ADDENDUM NO. 2 COVER SHEET

November 11, 2024

TERRE HAUTE AIRPORT AUTHORITY
WEST QUAD 6 UNIT BOX HANGAR PHASE 2
at
TERRE HAUTE REGIONAL AIRPORT (HUF)
TERRE HAUTE, IN
AIP 3-18-0082-057-2024

ADDENDUM NO. 2

SHEET NO:
CG101

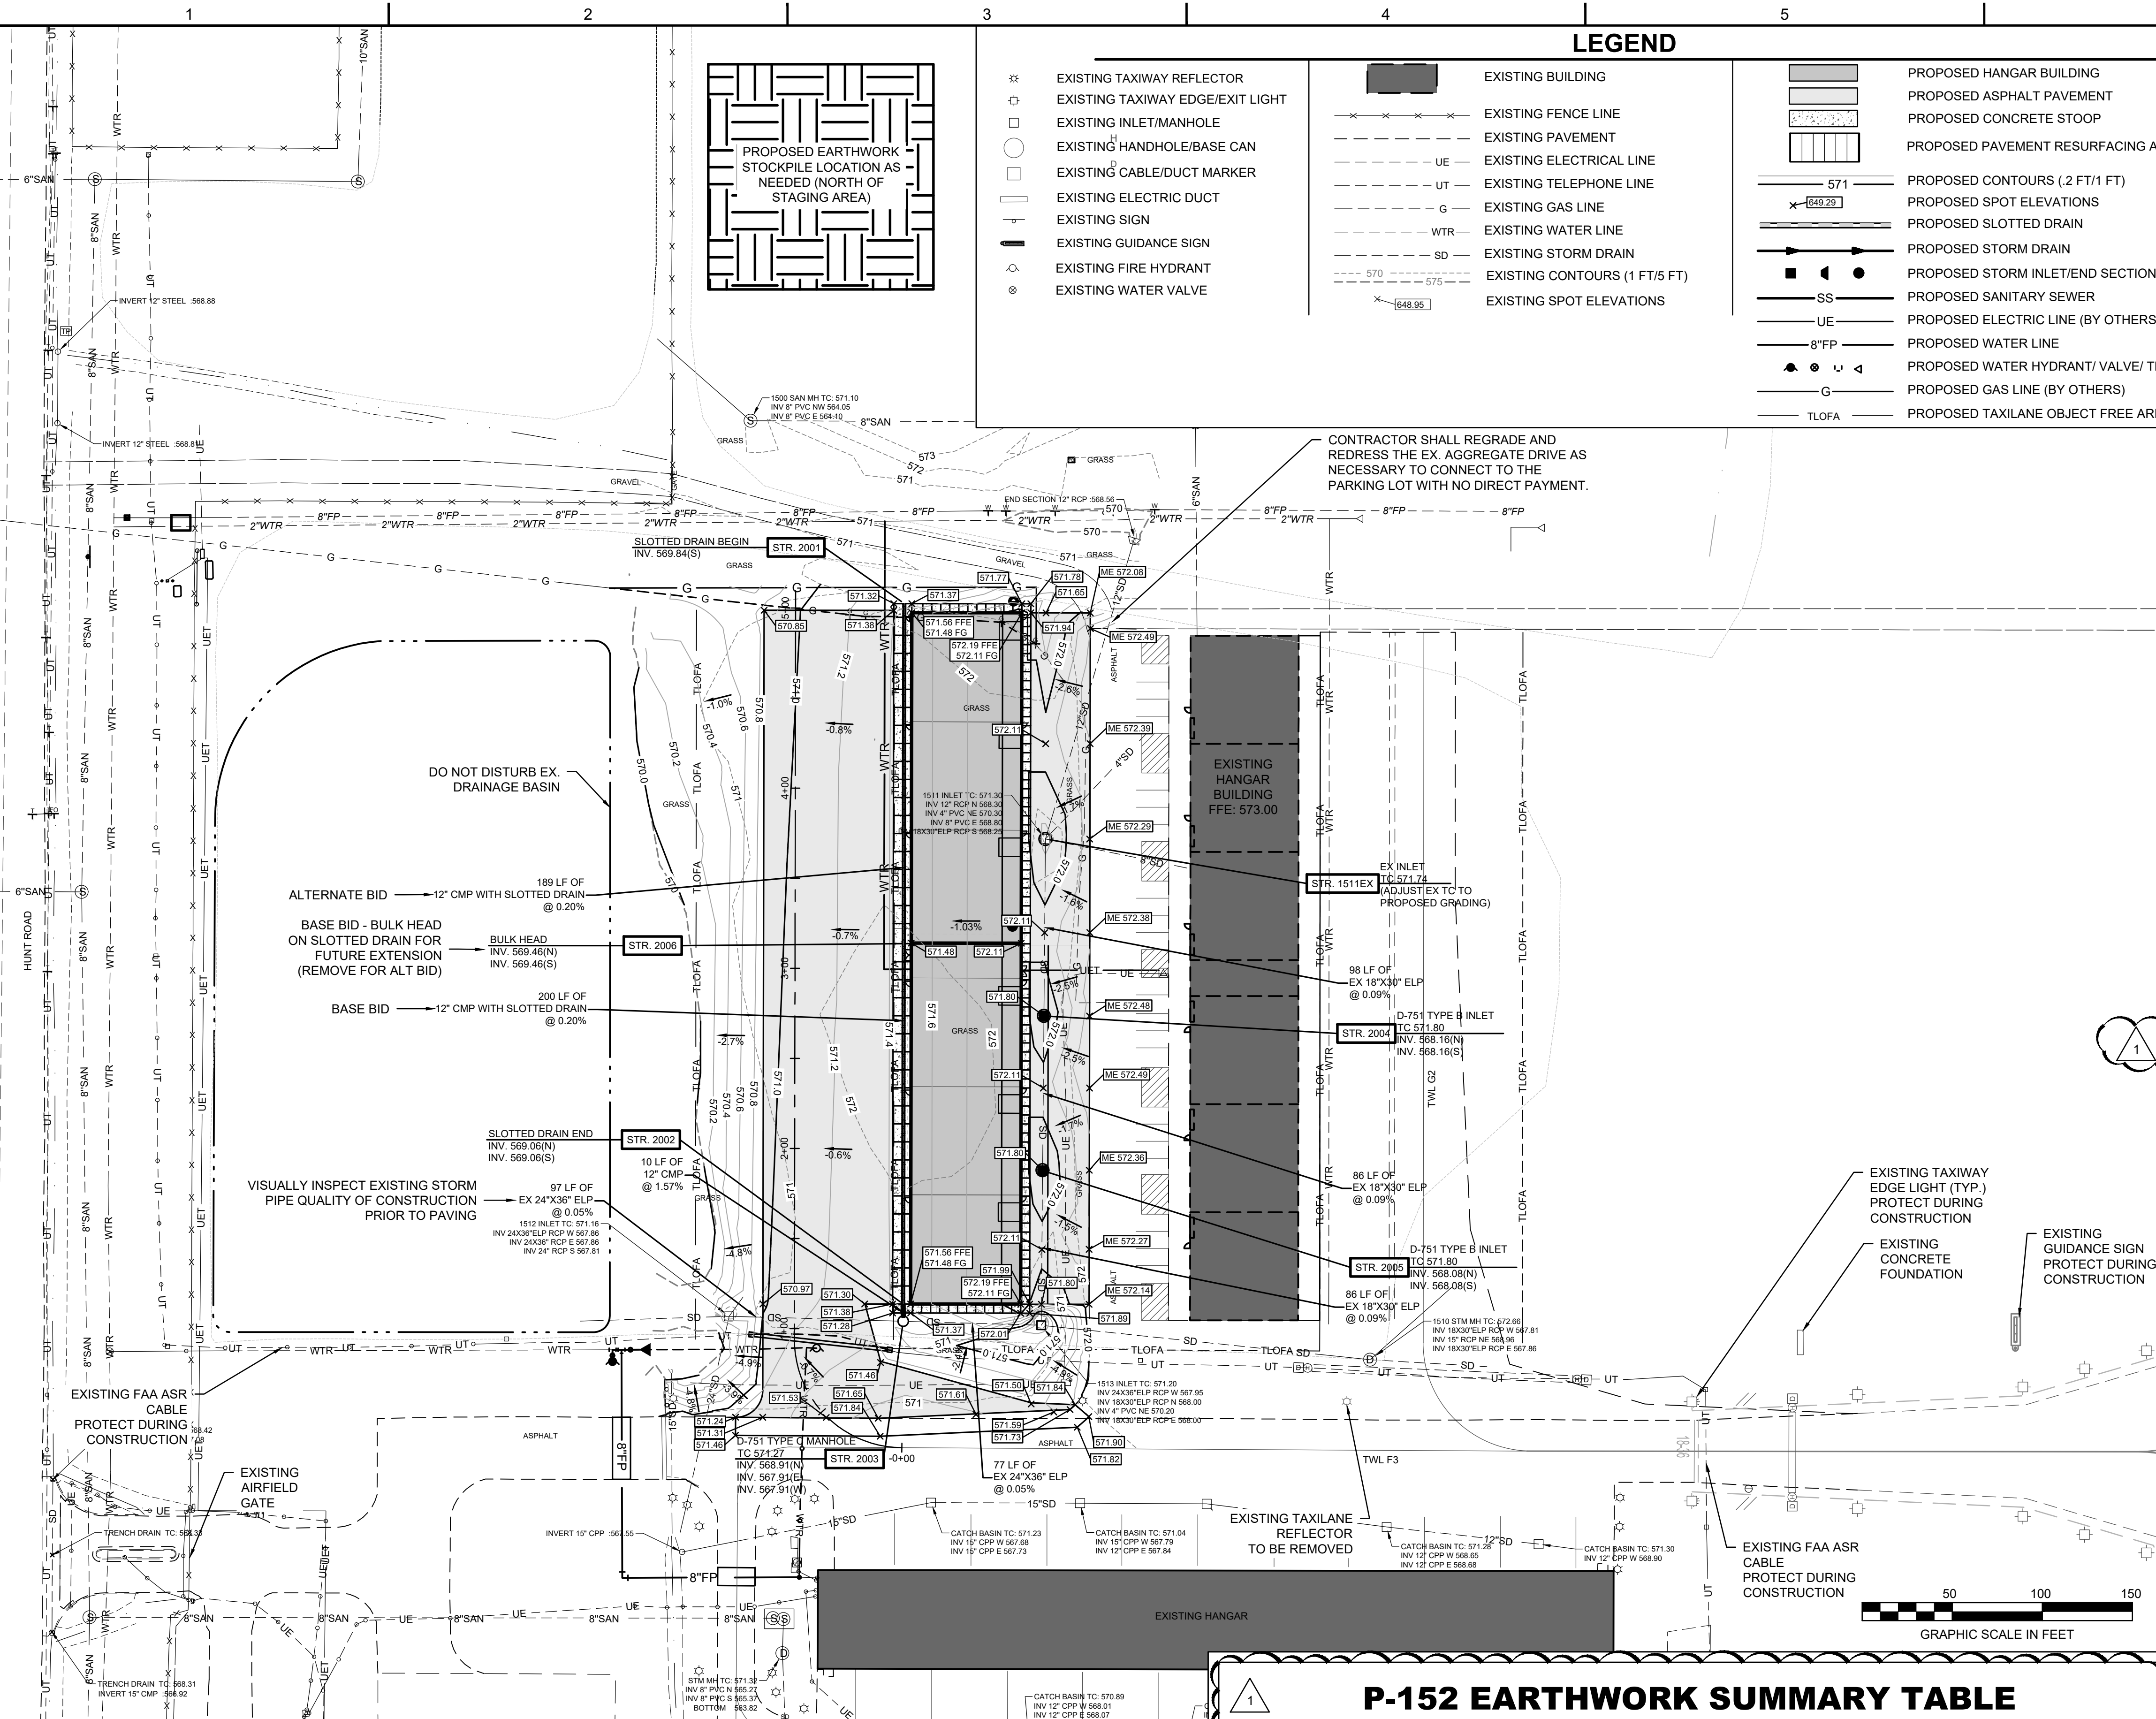
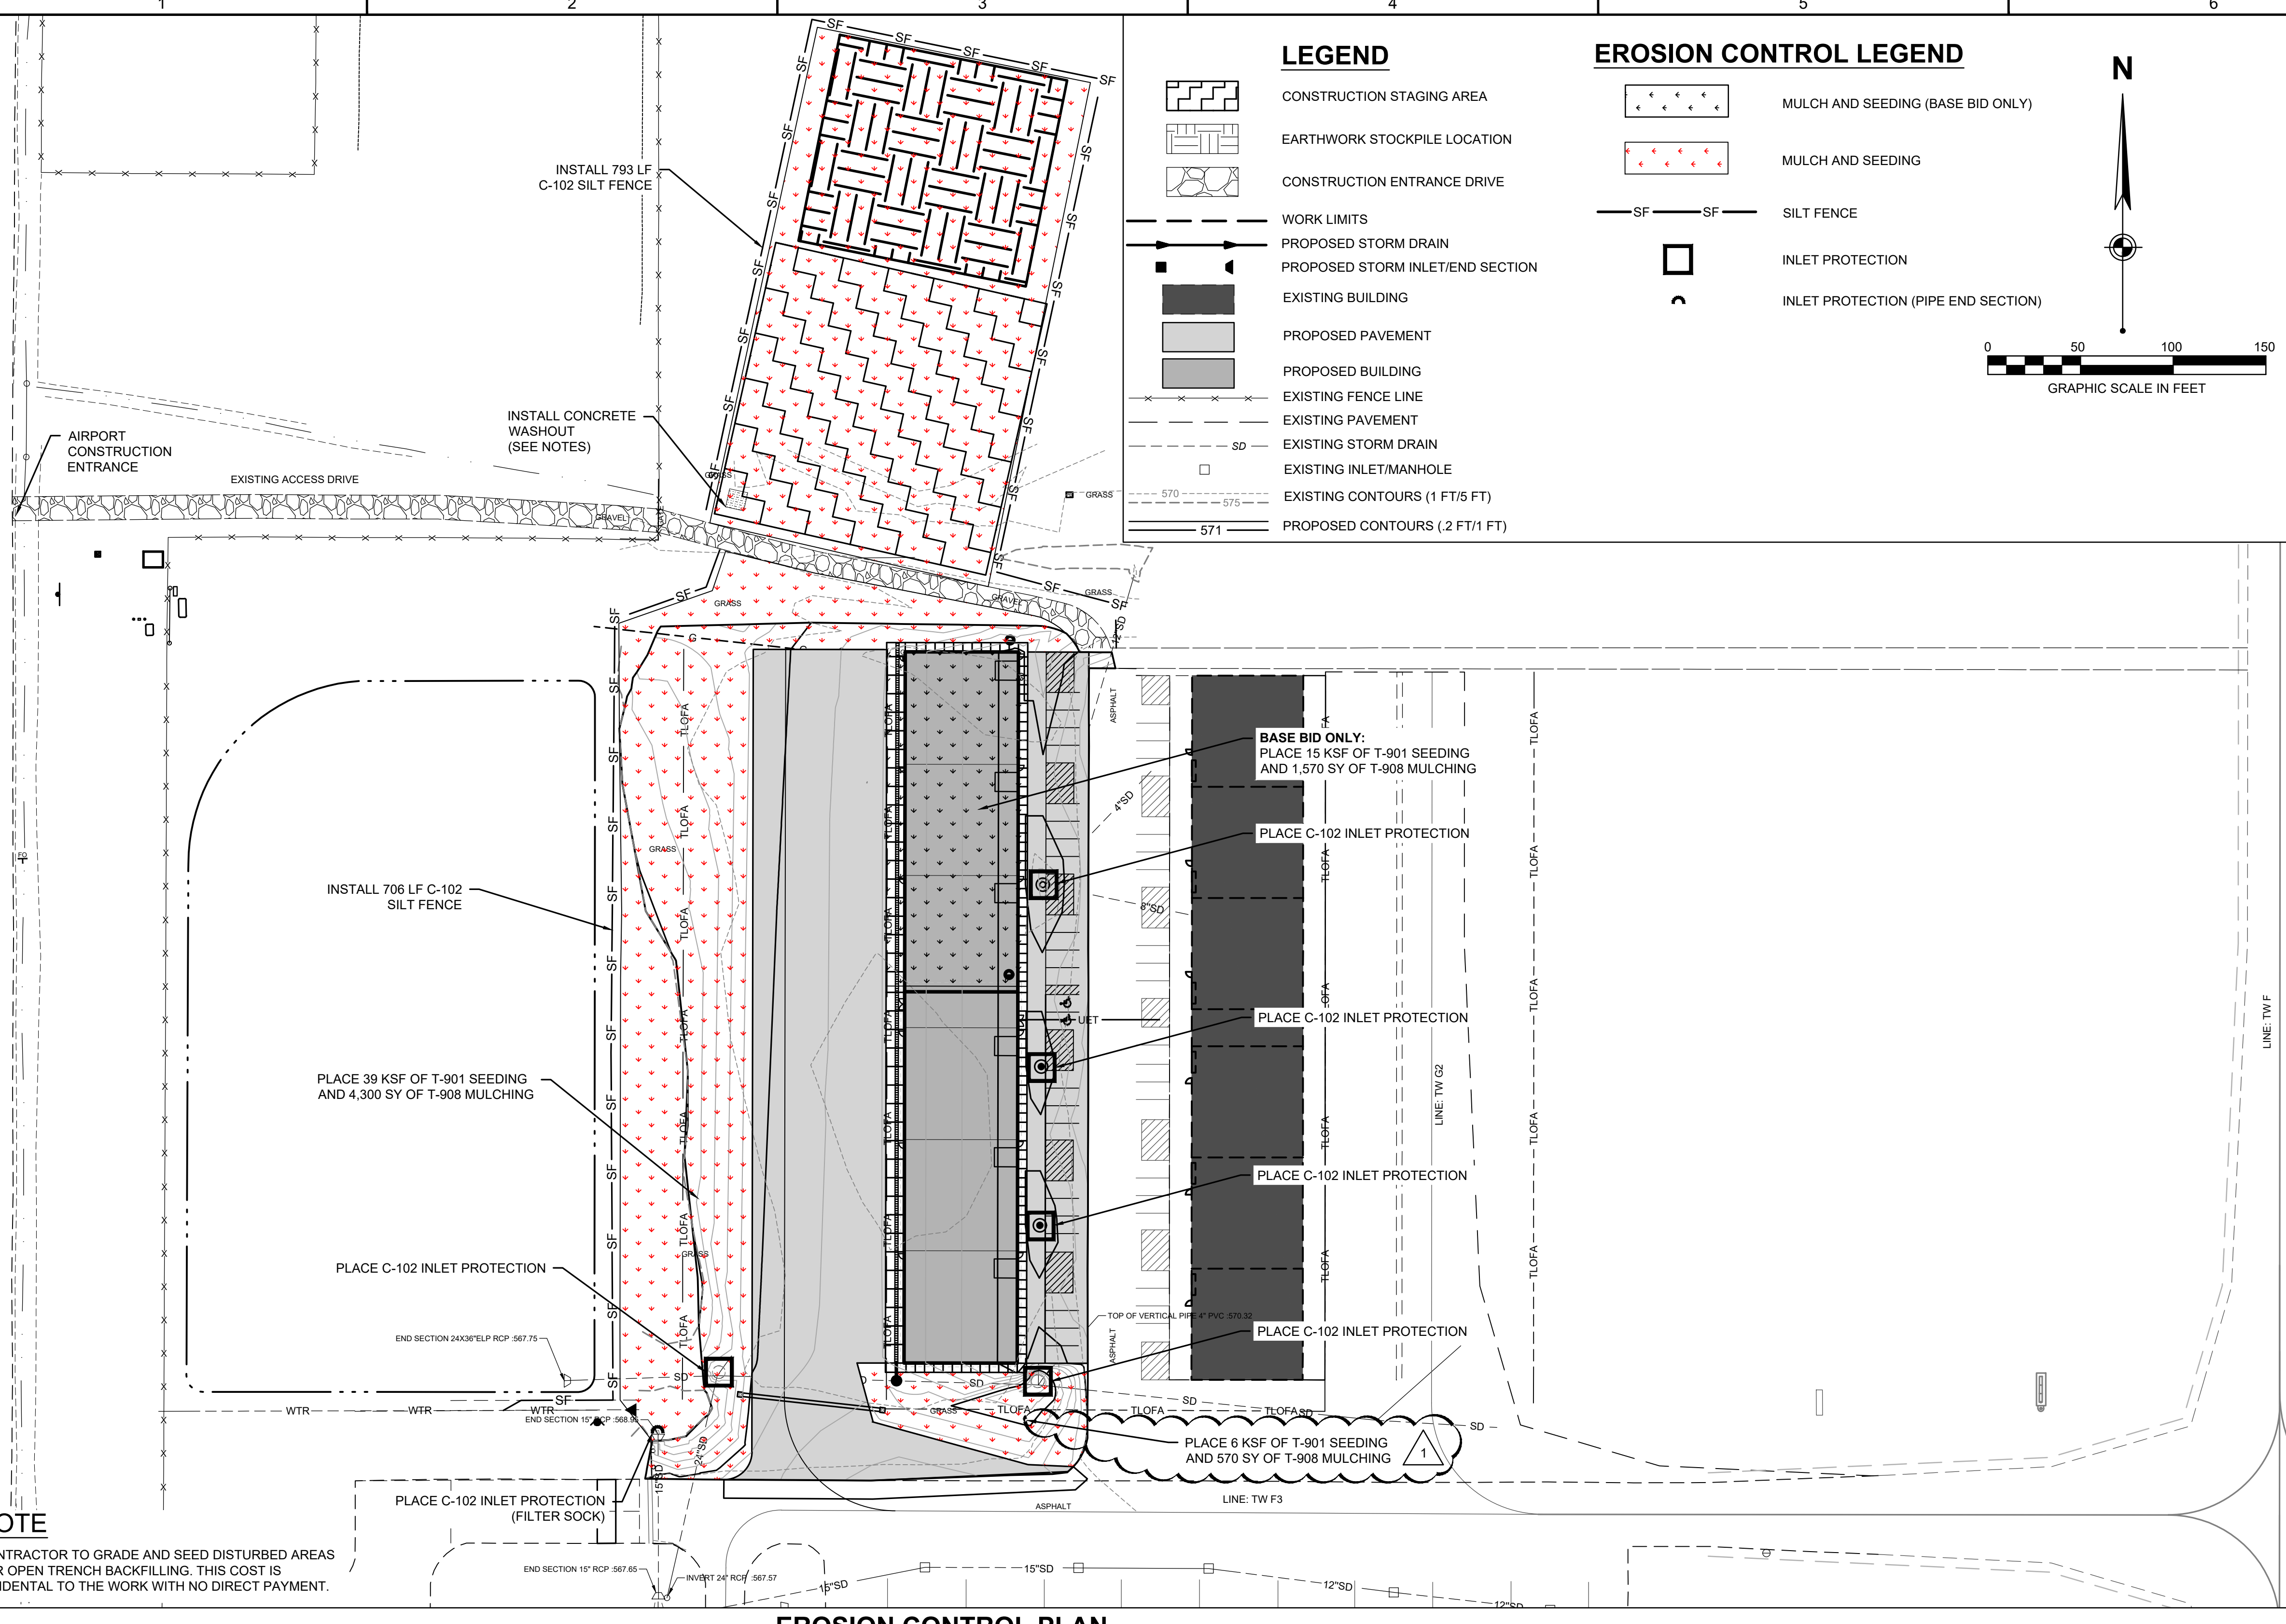
5. **Replace:** "CG101 Grading and Drainage Plan" dated October 18, 2024, with the revised drawing "**CG101 Grading and Drainage Plan**" dated November 8, 2024, issued with this Addendum.

6. **Question:** *Where will the stockpile for surplus soils be located?*
Answer: The stockpile for surplus soils will be located north of the staging area. Refer to CG101.

8. **Question:** *The unclassified excavation unit price quantity on C-002 table does not match the earthwork summary table on CG101.*
Answer: Refer to revised quantity in Addendum No. 2.

Answer: No, refer to CG101, Grading and Drainage Plan, Note 6.
16. **Question:** *Does the bid item "Concrete" also include the stone subbase under the concrete?*

17. **Question:** *There is no bid item for topsoil. Is topsoil required?*
Answer: Topsoil is required. Refer to CG101, Grading and Drainage Plan, Note 16 and Addendum No. 2.
